# **23 Gloucester Crescent**

# Design and Access Statement

Revised November 2021

This supporting statement forms part of a Listed Building Application seeking minor amendments to approval ref. 2021/2518/L (dated 06.08.2021) and is accompanied by the following documents:

Fig. 5 Boxed in waste pipe to cloakroom (plastered awaiting paint finish).

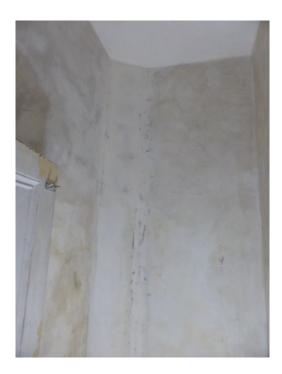
The bath and basin wastes from the First Floor were discovered to run under the floor to the centrally located rainwater goods on the West elevation. This was unacceptable from a building regulations perspective, and required connection to the internally routed SVP. The original SVP exits the duct and travels externally across the Hall roof, and the level of exit was above that of the bath/basin waste. The pipework therefore was run internally within the existing cloakroom, exiting at basement ceiling level to the South lightwell, where the pipework was set behind the existing SVP. This required 'boxing-in' to the corner of the cloakroom, executed with a panel a 45 degrees in the corner of the space to minimize visual impact, plastered and decorated as per the walls (Fig. 5), GC 303C.
